Re: Docket No. EPA-R06-OAR-2010-0190

COMMENTS

OKLAHOMA GAS AND ELECTRIC COMPANY

PROPOSED RULE REGARDING FEDERAL IMPLEMENTATION PLAN FOR  
INTERSTATE TRANSPORT OF POLLUTION AFFECTING VISIBILITY AND BEST  
AVAILABLE RETROFIT TECHNOLOGY DETERMINATIONS

**Figure V.1: Winhaze Images Showing Incremental Visibility Improvement at Upper Buffalo Class I Area from Dry FGD at Muskogee (0.84  $\Delta$ -dv)\***

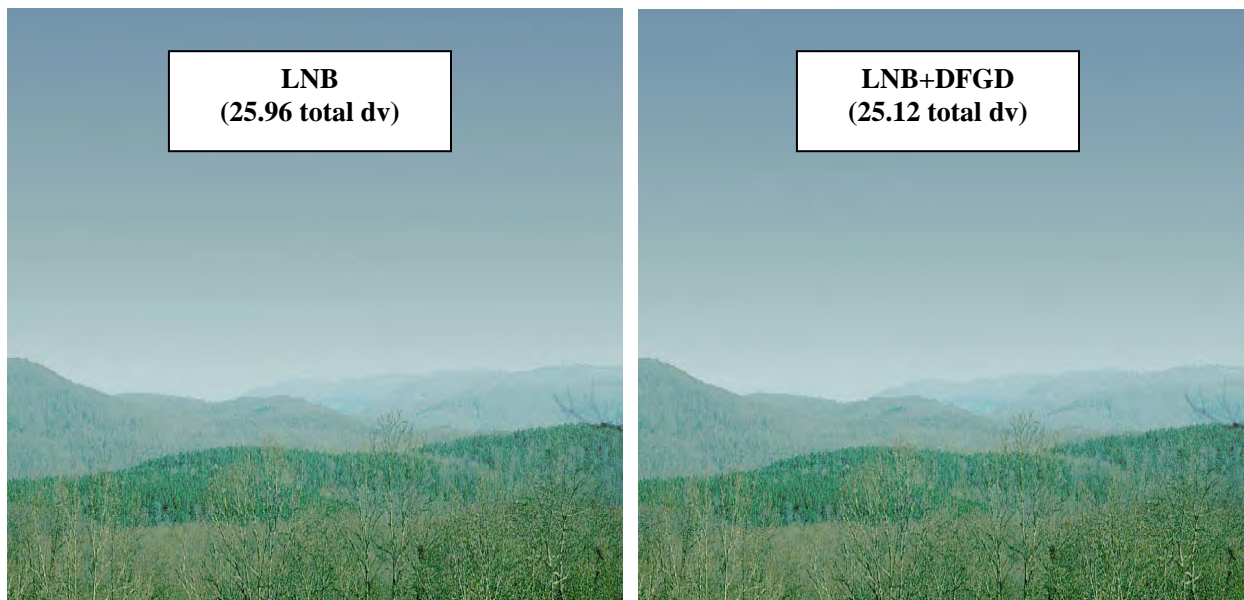
Figures V.1 and V.2 are Winhaze Software Images showing the maximum visibility improvement that is projected to occur at a Class I area as a result of adding Dry FGD at Muskogee and Sooner.<sup>19</sup> The left side of each Figure shows visibility conditions with the use of

LNB only, while the right side shows conditions with both LNB and Dry FGD. Figure V.1 reflects an incremental Dry FGD improvement of 0.84  $\Delta$ -dv at Upper Buffalo (25.96 dv minus 25.12 dv), which is not within the perceptible range. The maximum Dry FGD improvement reflected in Figure V.2 for Sooner (1.05  $\Delta$ -dv at Wichita Mountains) is only barely within the range thought to be perceptible to most people. Figure V.2, however, actually shows little-to-no perceptible change associated with Dry FGD over LNB.<sup>20</sup>

**Figure V.3: Winhaze Image Showing Incremental Visibility Improvement at Mt. Hood Class I Area from Adding Dry FGD at Boardman (3.56  $\Delta$ -dv) Without Early Closure**

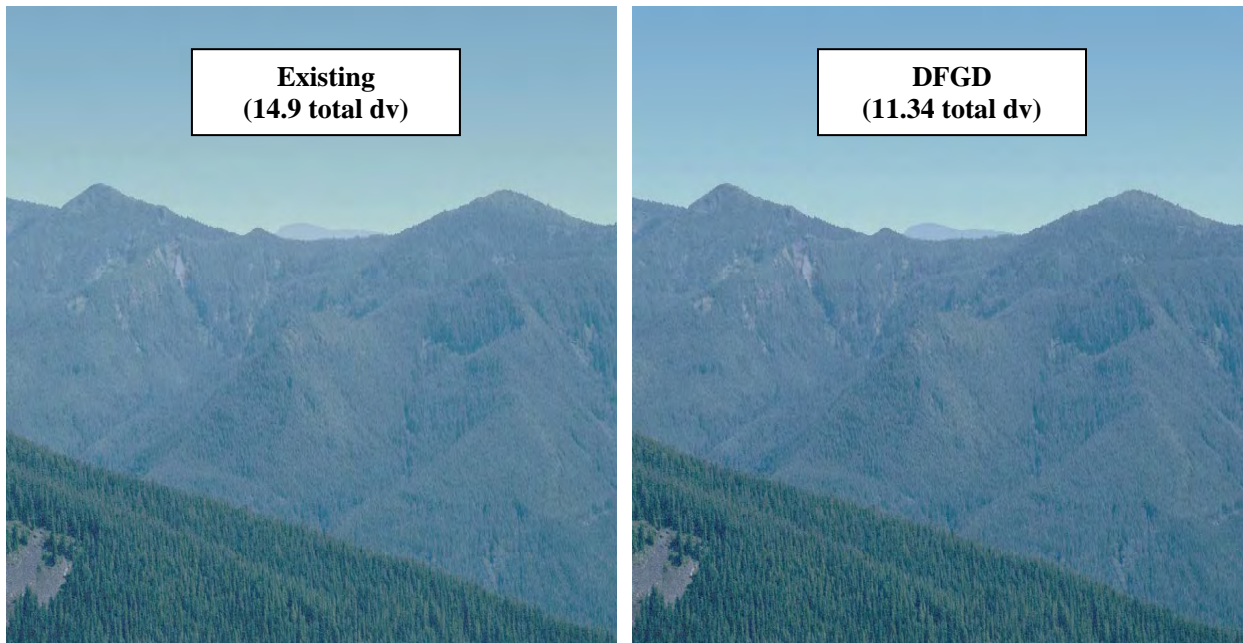
Boardman also differs from OG&E's facilities with respect to the maximum amount of visibility improvement projected for a single Class I area. Without early closure, scrubbers at Boardman would improve visibility by 3.56  $\Delta$ -dv at the Mt. Hood Class I area. The maximum visibility improvements projected for a single Class I area due to adding Dry FGD (rather than just LNBS) at Sooner and Muskogee are much lower—1.05  $\Delta$ -dv at Wichita Mountains and 0.84  $\Delta$ -dv at Upper Buffalo, respectively, according to Table 8 of the proposed FIP. Figure V.3 is a Winhaze Software Image showing the incremental visibility improvement from adding Dry FGD at Boardman without early closure. While Figures V.1 and V.2 above show little-to-no perceptible change from adding Dry FGD at Sooner and Muskogee, the improvement shown in Figure V.3 for Boardman is perceptible.

**Figure V.4: Winhaze Image Showing Incremental Visibility Improvement at Canyonlands Class I Area from Adding SCR at San Juan (3.11  $\Delta$ -dv)\***

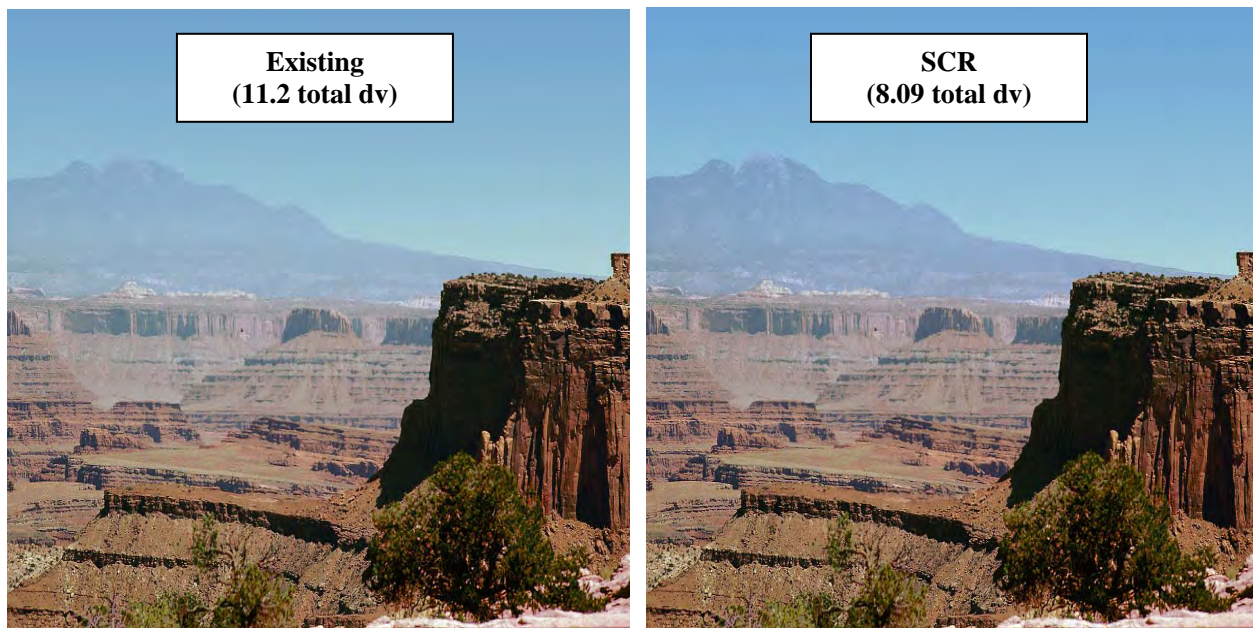
San Juan also differs from OG&E's facilities with respect to the maximum amount of visibility improvement projected for BART at a single Class I area. At Canyonlands, SCR for San Juan is projected to improve visibility by 3.11  $\Delta$ -dv, compared to maximum visibility improvements (as calculated by EPA) of just 1.05  $\Delta$ -dv and 0.84  $\Delta$ -dv for Dry FGD at Sooner and Muskogee, respectively. Figure V.4 is a Winhaze Image showing visibility improvement projected for the EPA-proposed NO<sub>x</sub> BART at San Juan. While Figures V.1 and V.2 above show little-to-no perceptible change from adding Dry FGD at Sooner and Muskogee, the improvement shown in Figure V.4 for San Juan is clear.

**Figure V.5: Winhaze Image Showing Incremental Visibility Improvement at Canyonlands Class I Area from Adding SCR at Four Corners (2.81  $\Delta$ -dv)\***

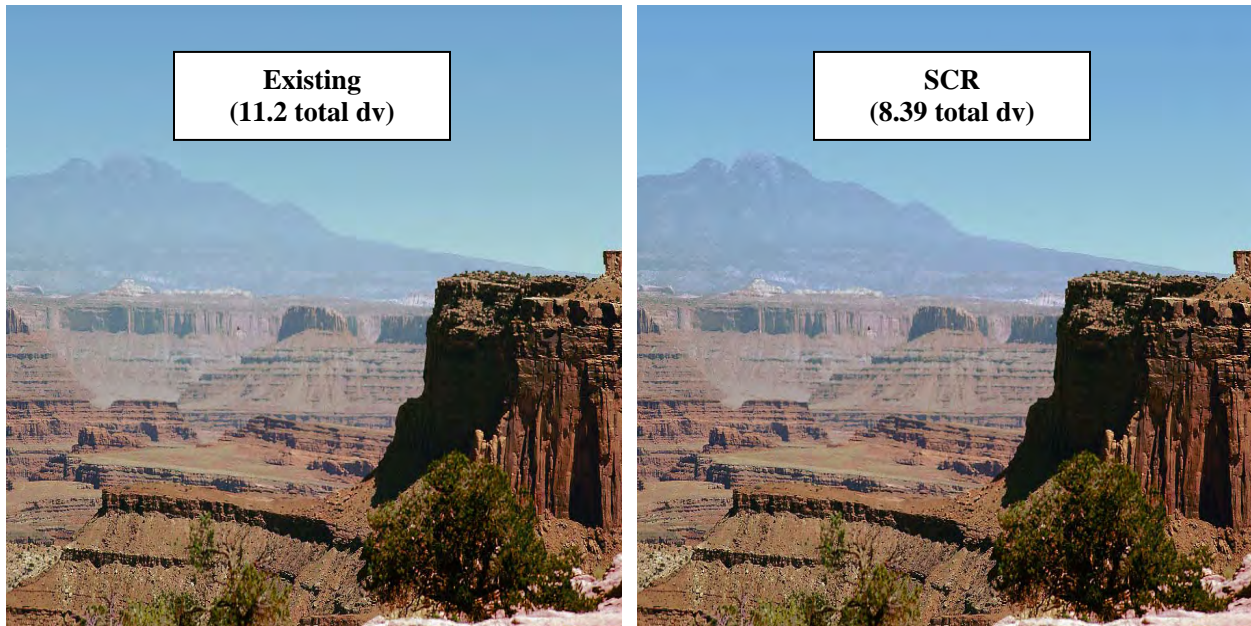
Four Corners also differs from OG&E’s facilities with respect to the maximum amount of visibility improvement projected for a single Class I area. SCR at Four Corners would improve visibility by 2.81 Δ-dv at the Canyonlands Class I area. *Id.* The maximum visibility improvements projected for a single Class I area due to adding Dry FGD (rather than just LNBS) at Sooner and Muskogee are much lower—1.05 Δ-dv at Wichita Mountains and 0.84 Δ-dv at Upper Buffalo, respectively, according to Table 8 of the proposed FIP. Figure V.5 is a Winhaze Software Image showing the incremental visibility improvement from adding SCR at Four Corners. While Figures V.1 and V.2 above show little-to-no perceptible change from adding Dry FGD at Sooner and Muskogee, the improvement shown in Figure V.5 for Four Corners is perceptible.
